**Coal Combustion Residue Impoundment
Round 9 - Dam Assessment Report**

Plant Gadsden

Fly Ash Dike

Alabama Power Company
Gadsden, Alabama

Figure 5.2.1-1: Lower Pond Crest West End of North Dike

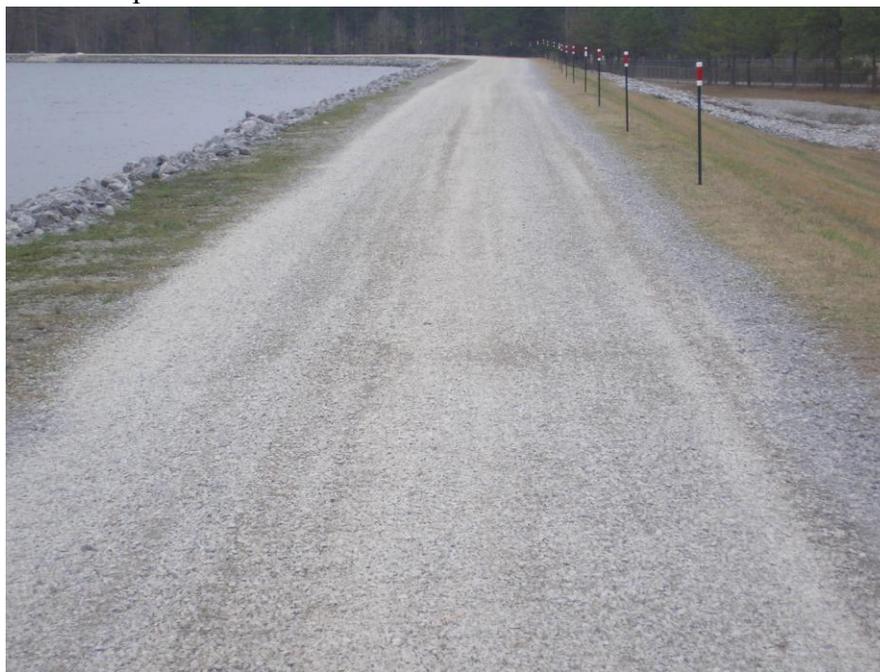
The crest of the impoundment embankment has no signs of depressions, tension cracks, or other indications of settlement or shear failure. Previous inspection reports reviewed by Dewberry did not indicate issues concerning the embankment crest. Figure 5.2.1-1 shows the condition of the lower pond crest.

Photo 8: Discharge Pipe in Ash Pond

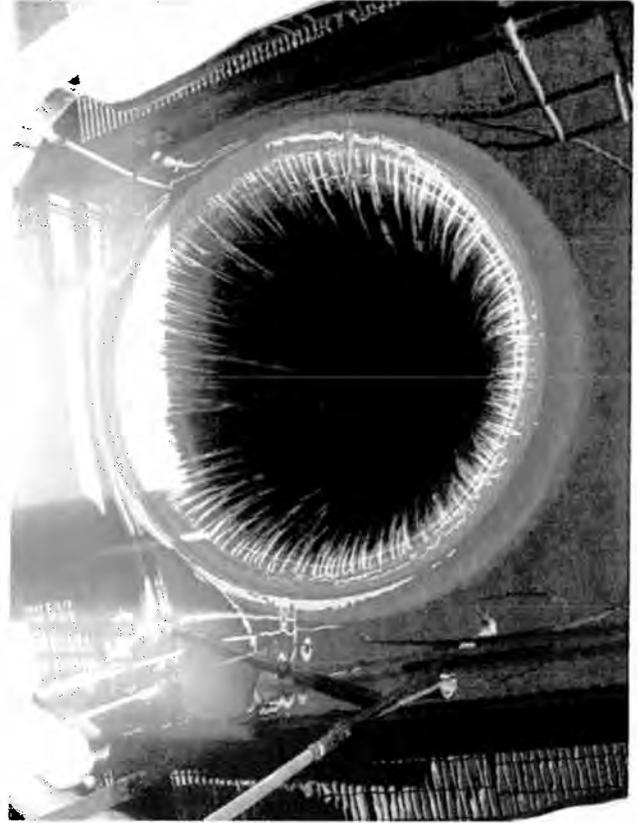
No.	Description	Location
1	Eradicate all ant mounds on the embankments using pesticides.	1979 Extension Embankment (Photo 3)
2	Armor the upstream side of the crest of the embankment structures to protect against wave action induced erosion. The armoring can be achieved using riprap.	1979 Extension Embankment (Photo 4)
3	Clear vegetation and trees to a distance of 5 feet beyond the downstream toe of water-retaining embankments. At this time, large trees (i.e. greater than 4 inches in diameter) may be left in-place.	1979 Extension Embankment (Photo 5)
4	Remove fairly dense vegetation from northernmost corner of 1979 Extension Embankment (see Photo 6). The removal should be performed by bush-hogging (where accessible) or use of herbicides.	1979 Extension Embankment (Photo 6)

Photo 5: Typical Vegetation Encroachment on Downstream Toe

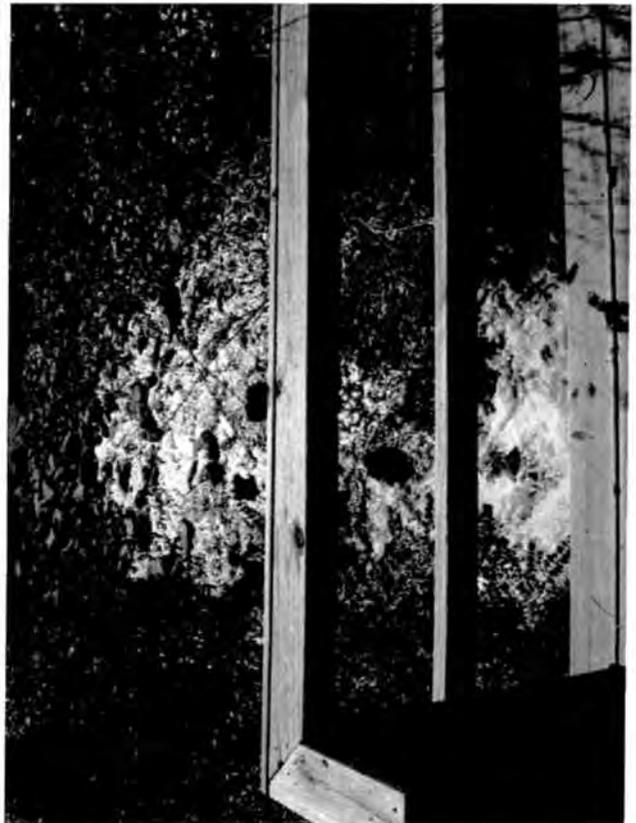
The need to continue efforts to keep the downstream slope and the area around the toe of the dike free from brush and trees was discussed (Photo 5). It is the recommendation of the inspection team that the downstream area of the dam be cleared and maintained to a distance of at least 5 feet past the toe. Any large trees in this area (greater than about 4 inches in diameter) could be left at this time due to the difficulties associated with their removal, but any shrubs or other small plants should be cleared. At the northernmost corner of the dike, fairly dense vegetation was observed on the embankment and at the toe (Photo 6). It is recommended that this vegetation be removed by bush-hogging (where accessible) or spraying herbicide.

Photo 8: Evidence of Beaver Activity in the Dam Area

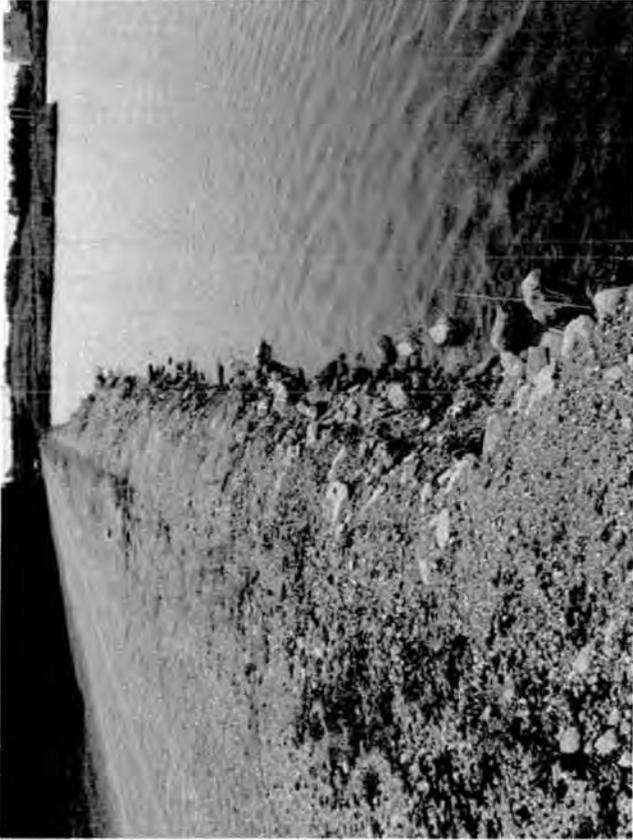
During the inspection, evidence of small animal activity, most likely beavers, was noted (see Photo 8). At this time the animal activity does not appear to be having any negative effect on the ash pond, but this should be monitored by the plant staff during their regular inspections.

Photo 9 – Beaver Activity (Trail) at 1979 Extension Embankment

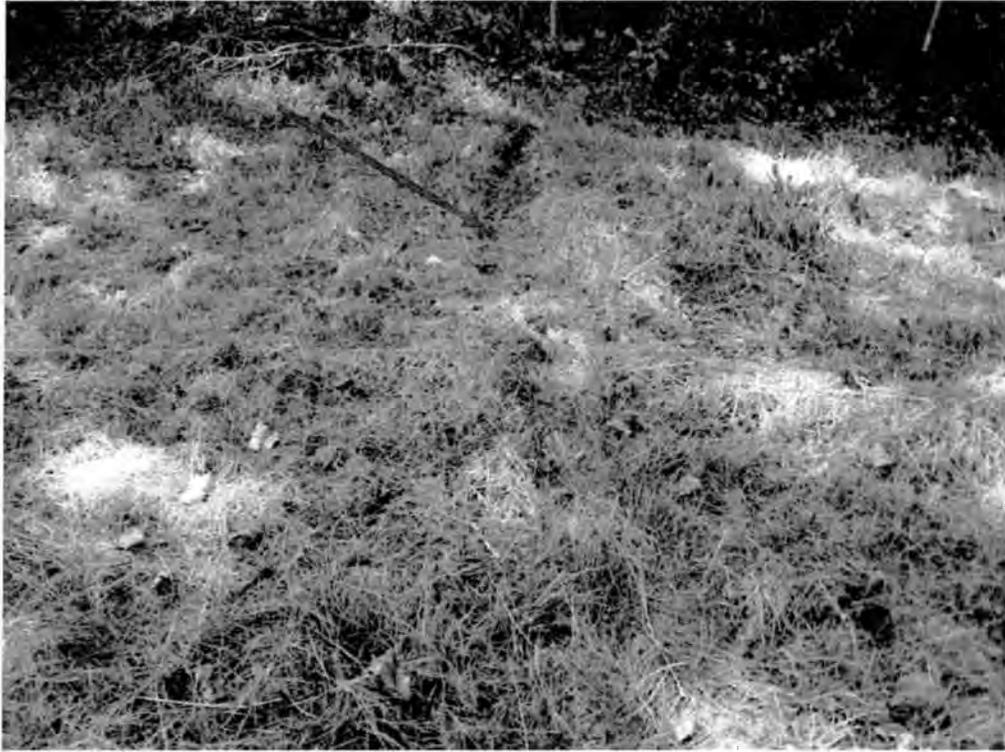
During the inspection, evidence of animal trails to the pond, most likely made by beavers, was noted (see Photo 9). At this time the animal activity does not appear to be having any negative effect on the ash pond, but this should be monitored by the plant staff during their regular inspections.

On the far western edge of the lower pond, a few large stumps from past tree removal were observed in the dam toe (see Photo 10). ***While the plant staff (or their contractor) is mobilized to clear trees on the original dike section, it is recommended that these stumps be removed.*** Disturbed embankment soils and/or holes resulting from the stump removal should be treated as recommended above, and exposed embankment soils should be seeded after they are compacted.

No.	Description	Location
1	The trees along the original ash pond embankment (upstream and downstream) should be removed. The trees on the downstream face should be removed to a distance of 20 feet downstream of the toe where practical.	Original Dike (see Photos 1, 2, and 3)
2	Drainage in the drainage ditch along the upstream face of the original ash pond embankment should be improved. As plans progress, the plant should continue to keep SCG Hydro Services informed.	Original Dike (see Photo 4)
3	The woody debris noted beneath the transmission line should be cleared to provide an unobstructed view of the embankment downstream face.	Original Dike (see Photo 5)
4	It is recommended that the level of maintenance observed along the 1979 Extension dike structure be continued for all ash handling structures at Gadsden SP.	All Structures
5	Stumps observed along the western edge of the 1979 Extension dike should be removed.	1979 Extension Dike (see Photo 9)
